CERTIFICATE OF APPROPRIATENESS

Property: 825 Columbia, Lot 6, Block 250, Houston Heights Neighborhood Subdivision. The property includes a historic 3,267 square foot, two-story single-family residence and detached 440 square foot noncontributing garage situated on a 6,600 square foot (50' x 132') interior lot.

Proposal: Alteration – Addition and Rear Porch

SECOND FLOORPLAN

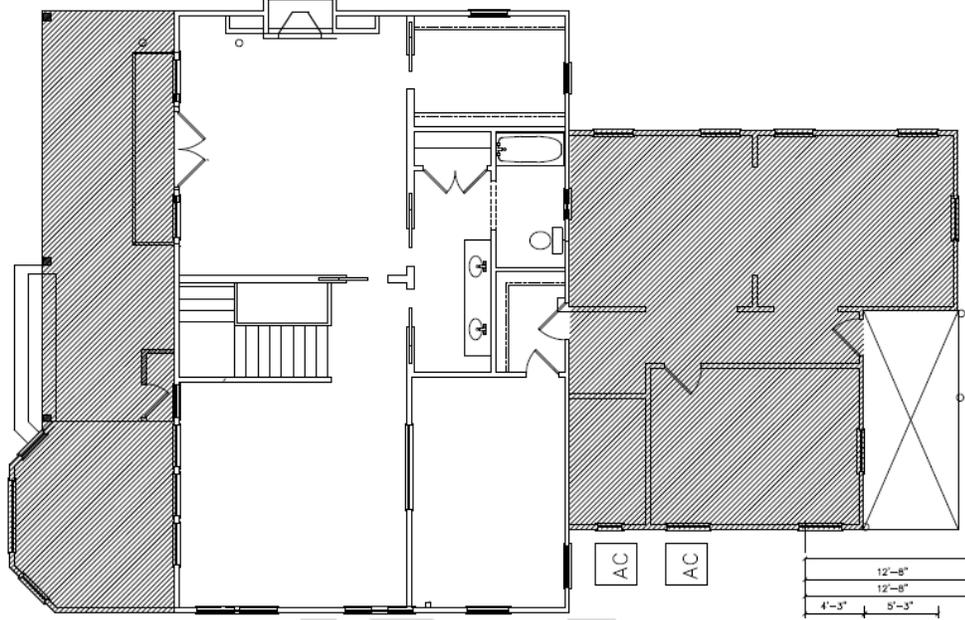
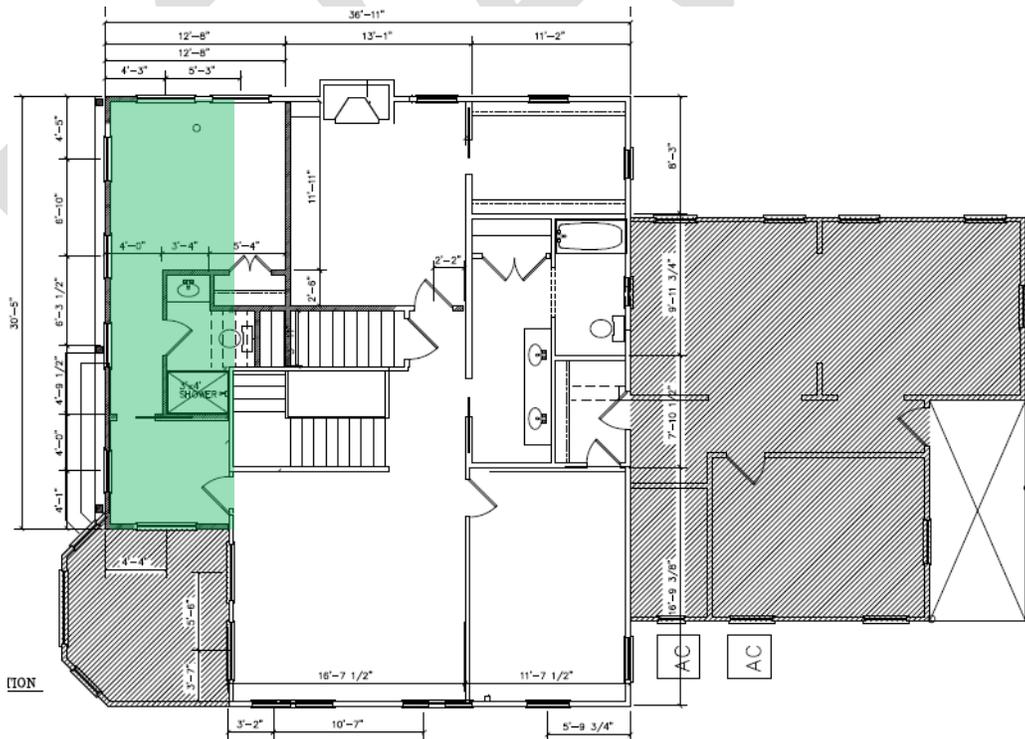
(10) The proposed alteration or addition must be compatible with the massing, size, scale material and character of the property and the context area; and
The proposed addition exceeds FAR and Heights Measurable Standards.

(11) The distance from the property line to the front and side walls, porches, and exterior features of any proposed addition or alteration must be compatible with the distance to the property line of similar elements of existing contributing structures in the context area.
The existing structure does not meet measurable standards and the proposed addition does not meet side setbacks or FAR.

Existing Lot Size: 6,600
 Max. FAR Allowed: 2,904
 Proposed FAR: 3,486
 Remaining Amount: -582

Recommendation: Partial Approval: Approval of the rear porch as submitted, without conditioned space above it.
HAHC Action: -

LEFT ELEVATION

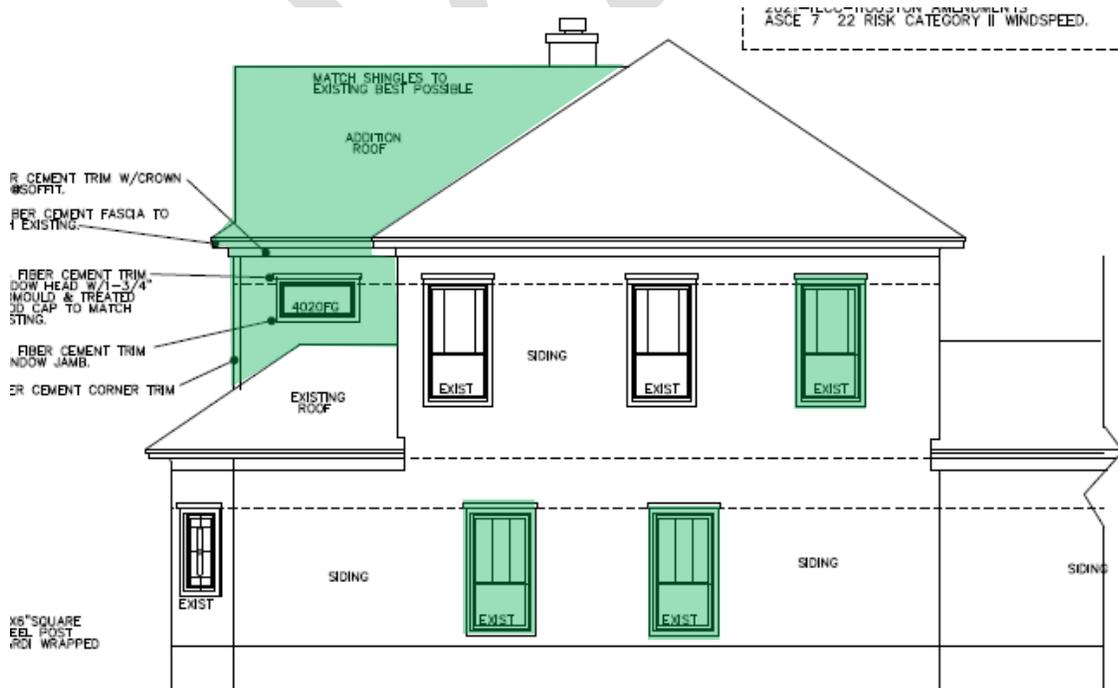
Proposed side setback (1): 3'-0"

Proposed side setback (2): 3'-0"

Cumulative side setback: 6'-0"

- Existing house side setbacks are at 3'-0" (6' cumulative) on both north and south side elevations. While the proposed does not meet measurable standards, 3'-0" would match the existing building side setbacks.
